Site Instruction

SI 24

PROJECT : Hampton Manor
PROJECT No : 1136.13
DATE : August 14, 2018

Title: Removal of Insulation behind Precast

as noted A653

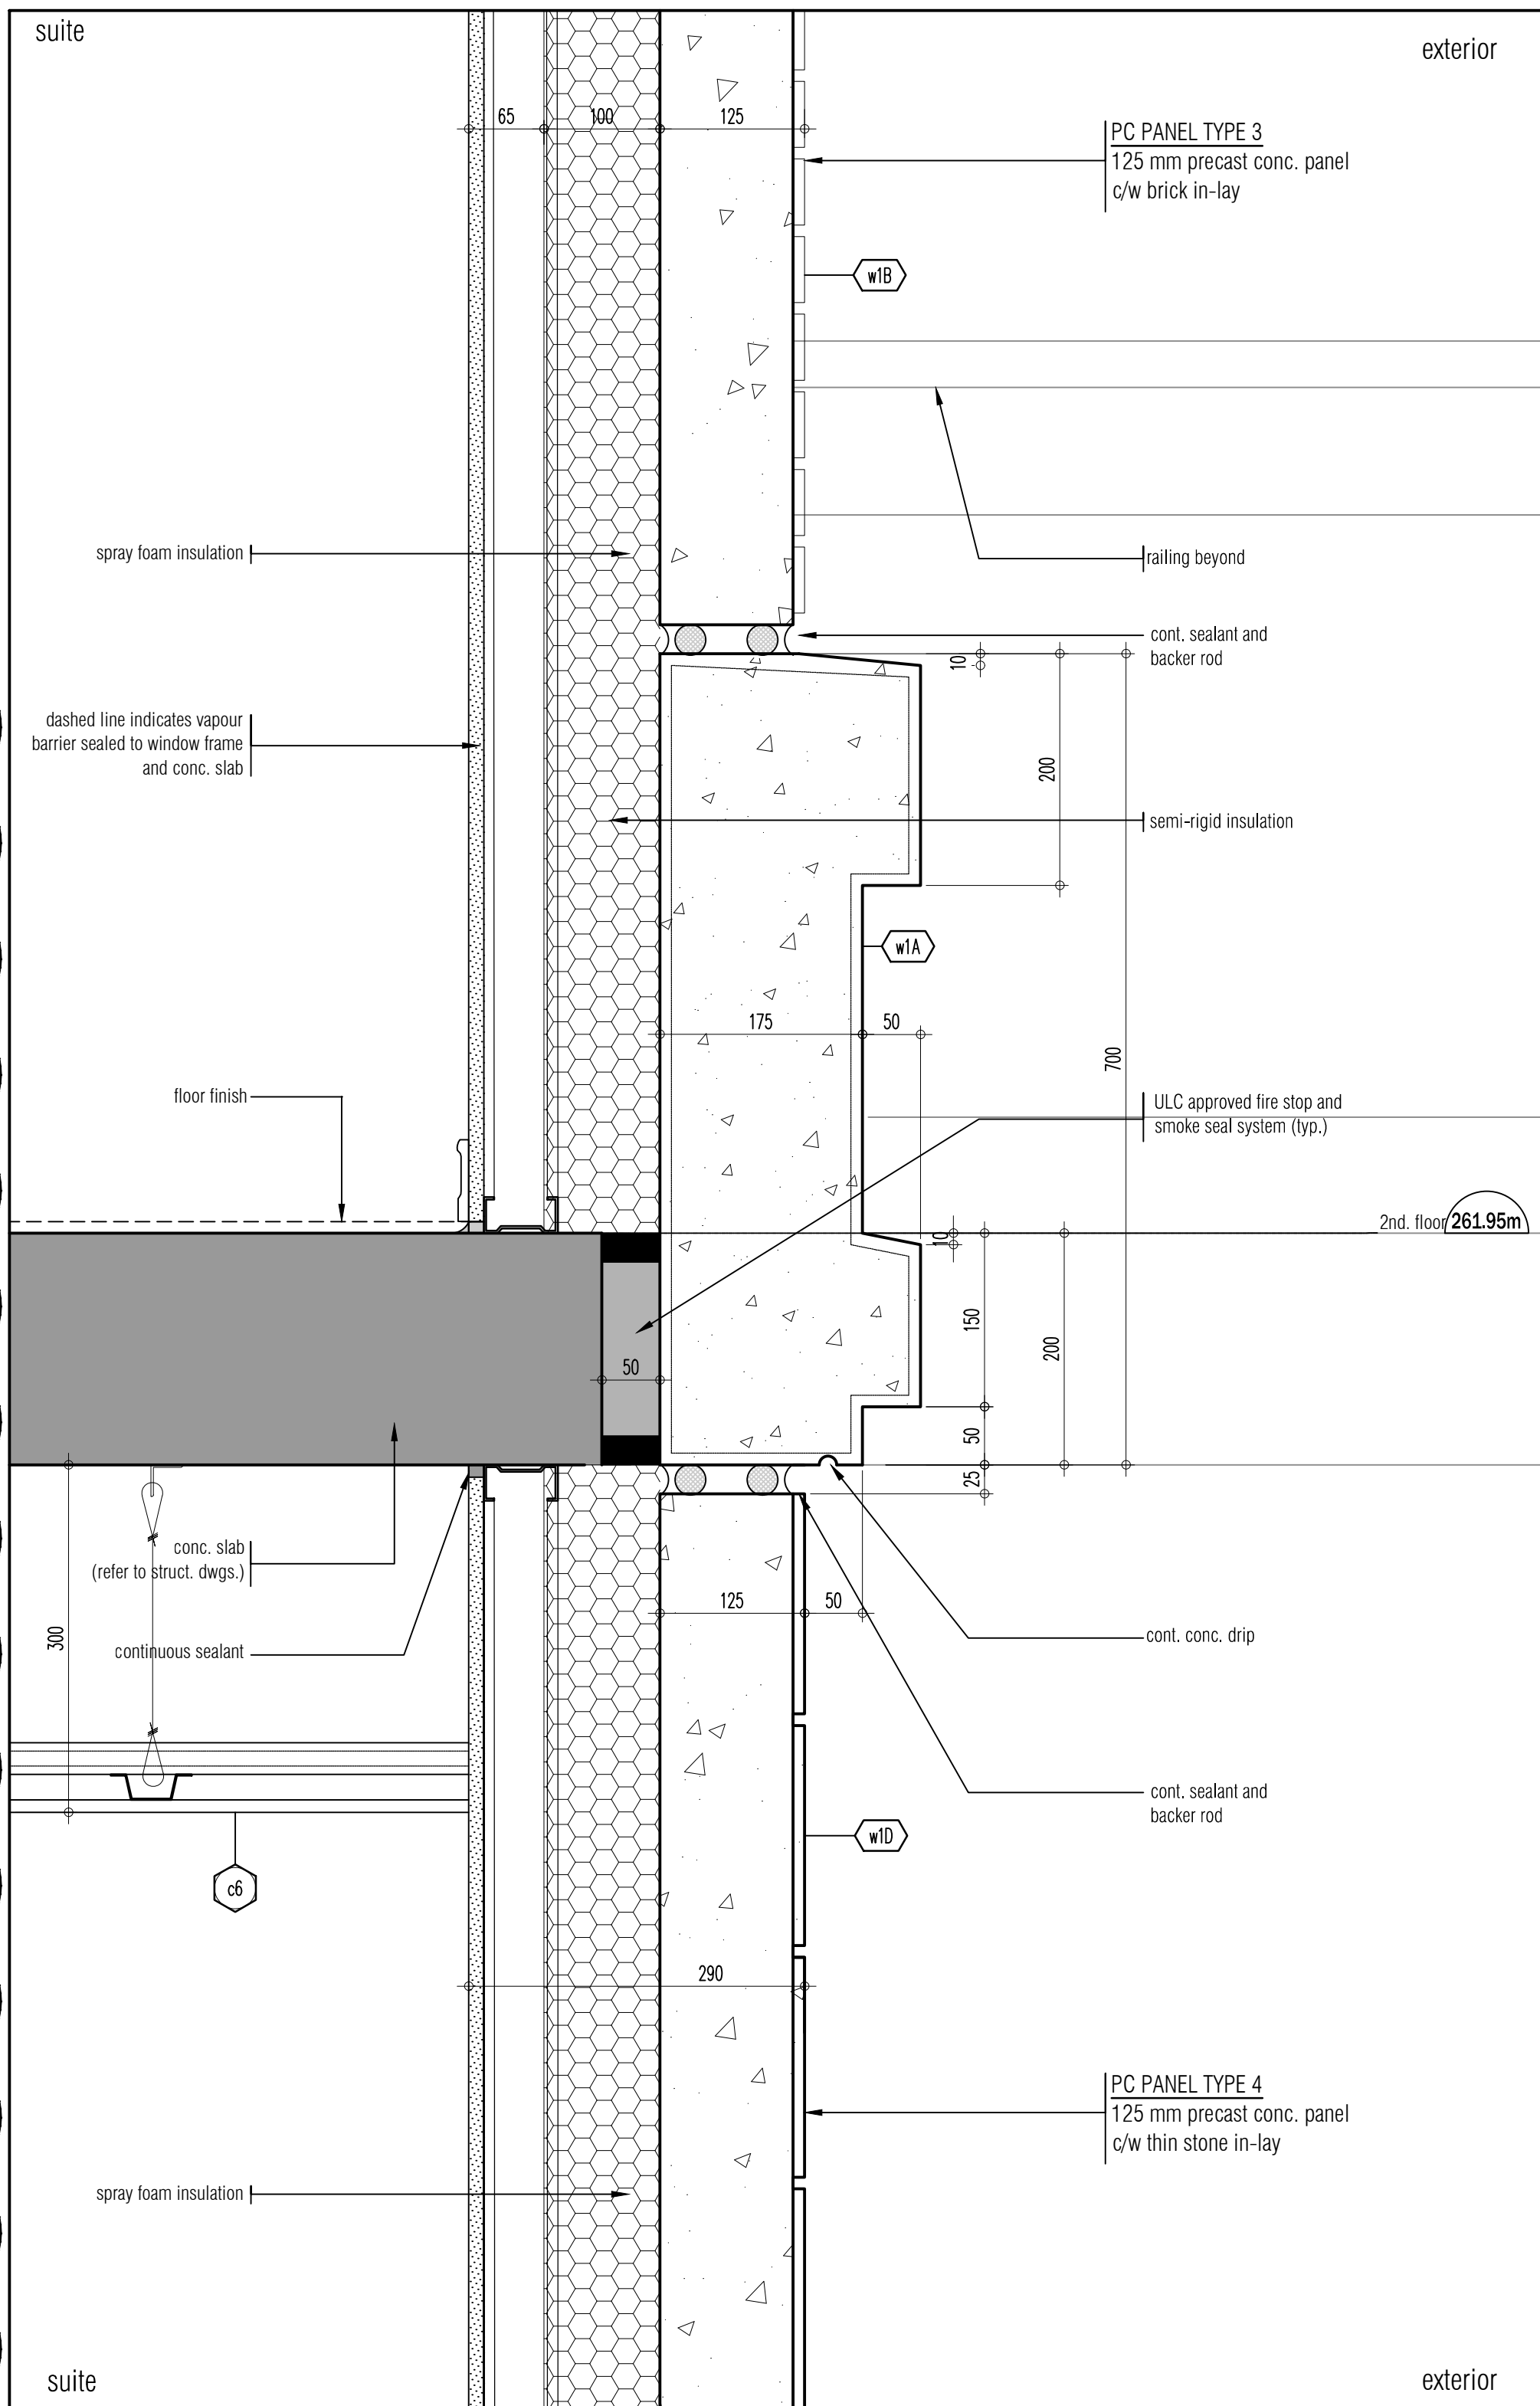
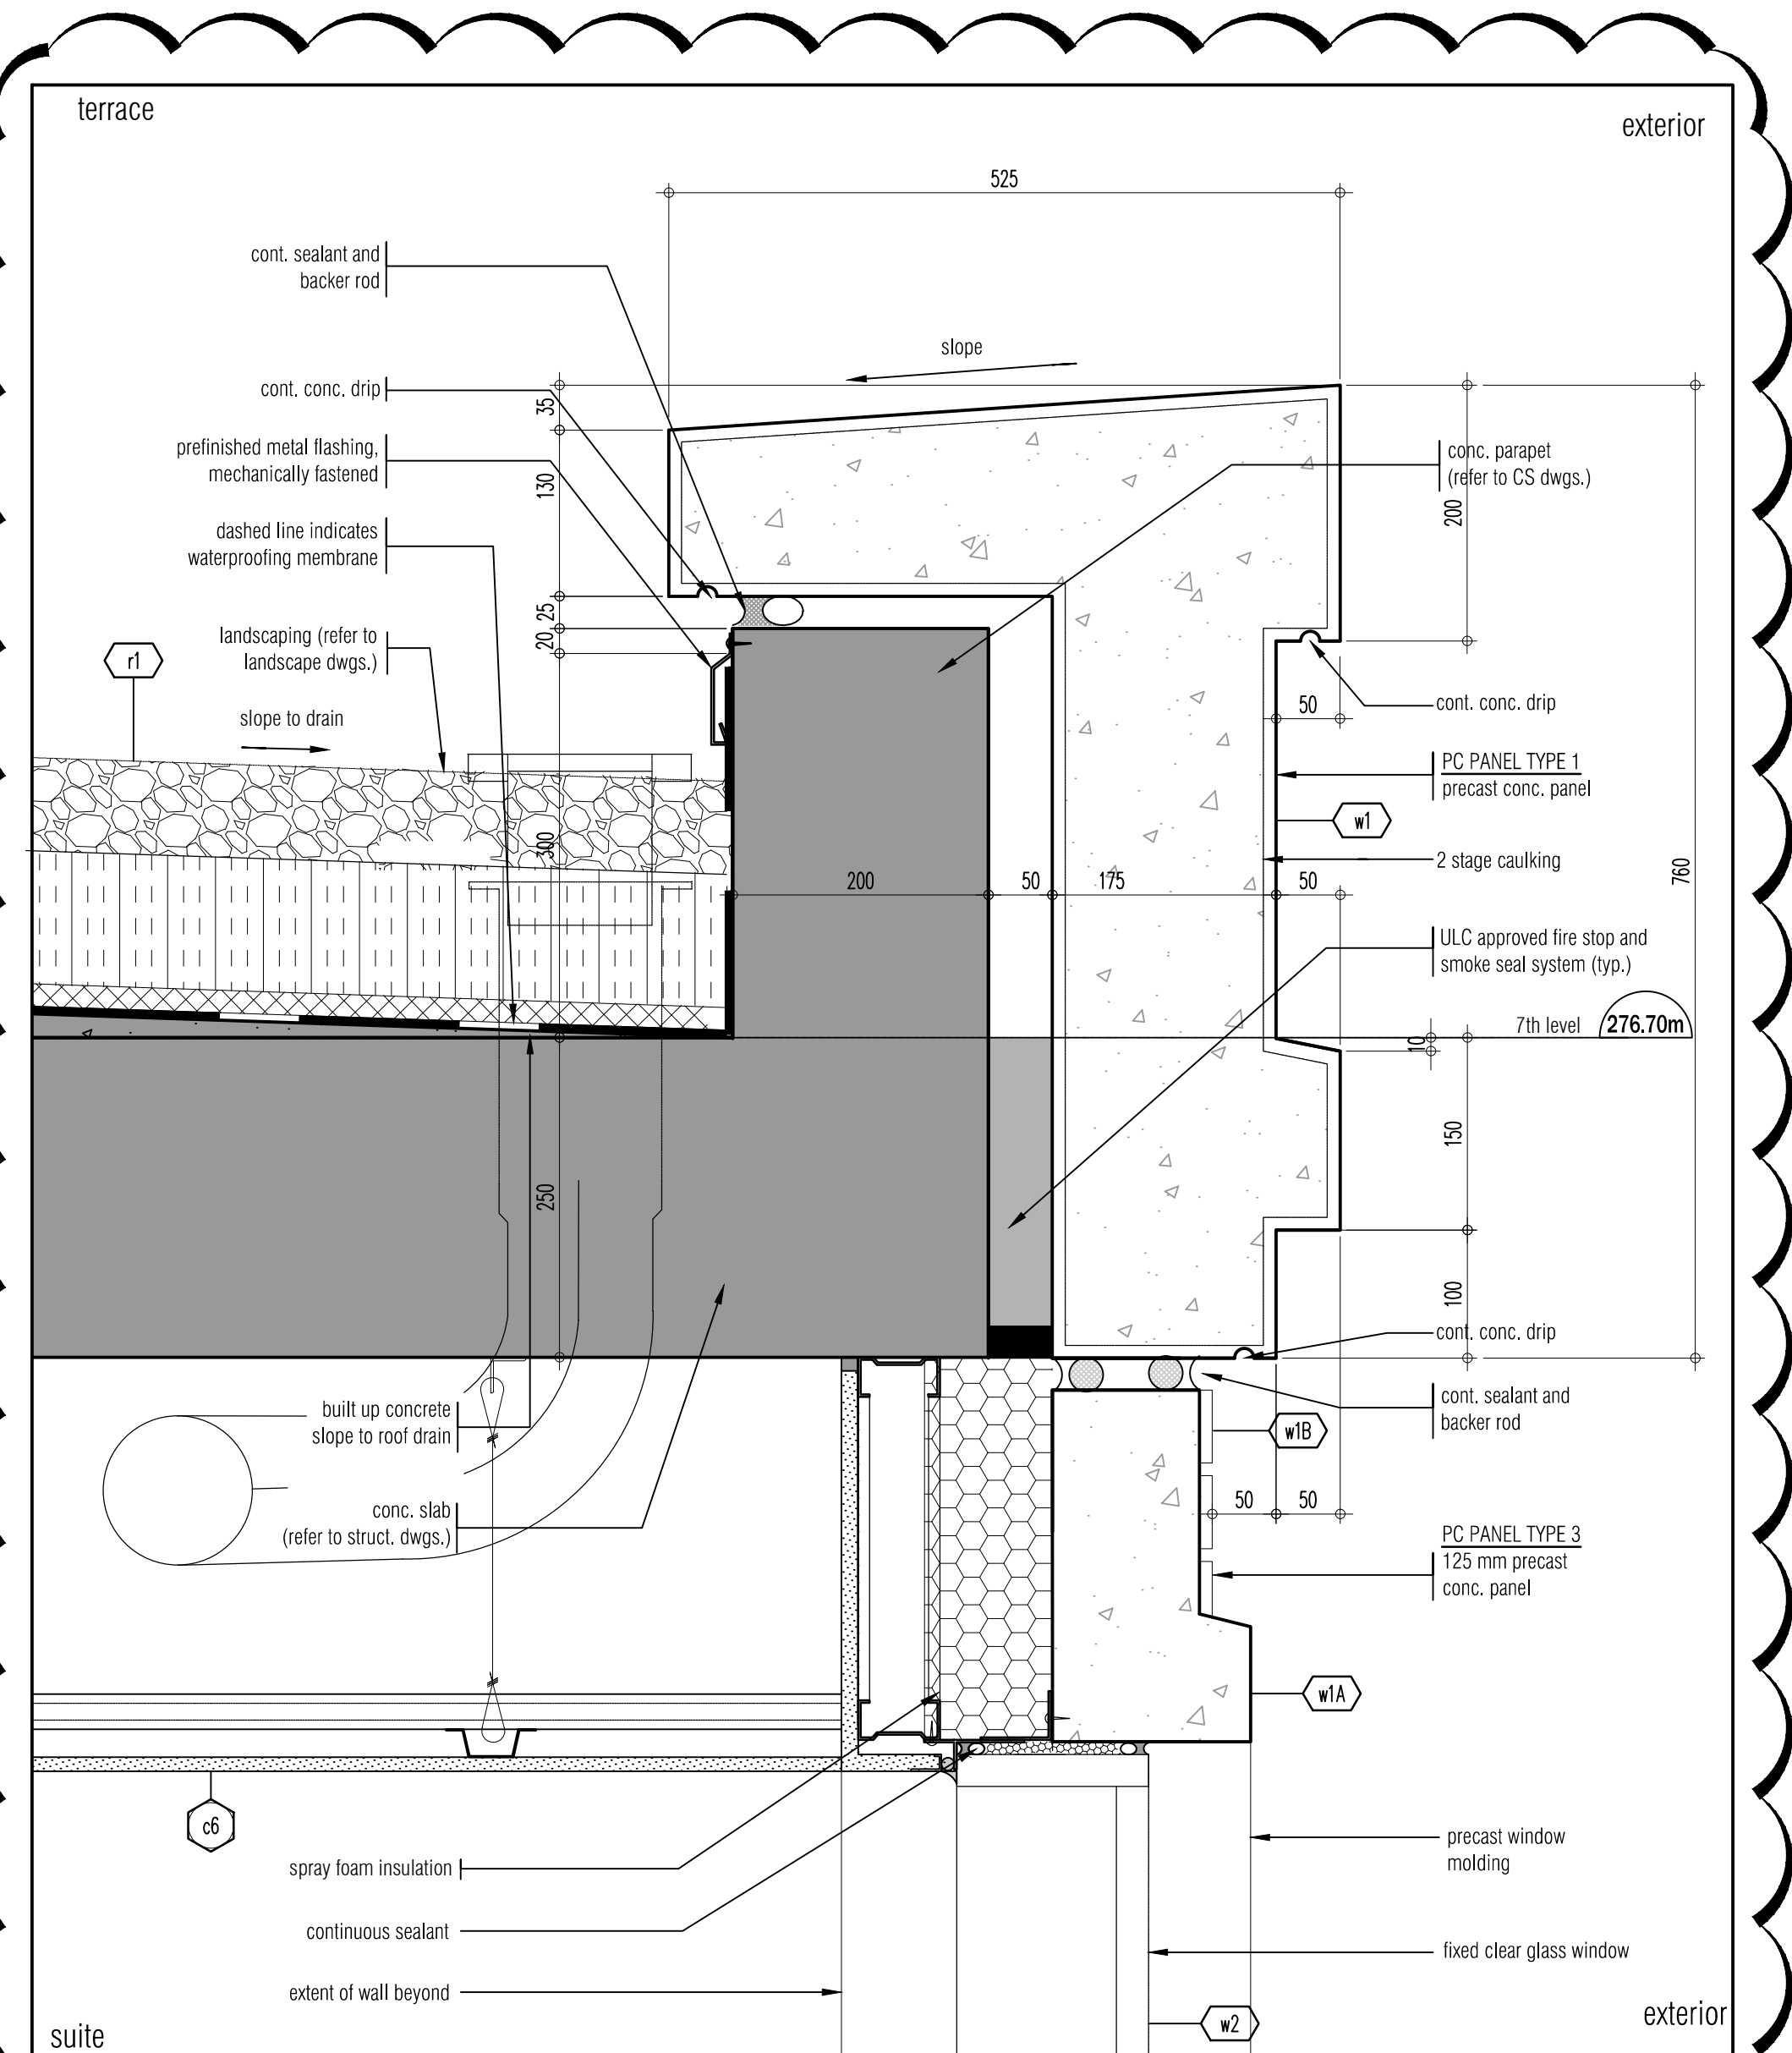
- Removal of insulation behind precast at terraces and roof.
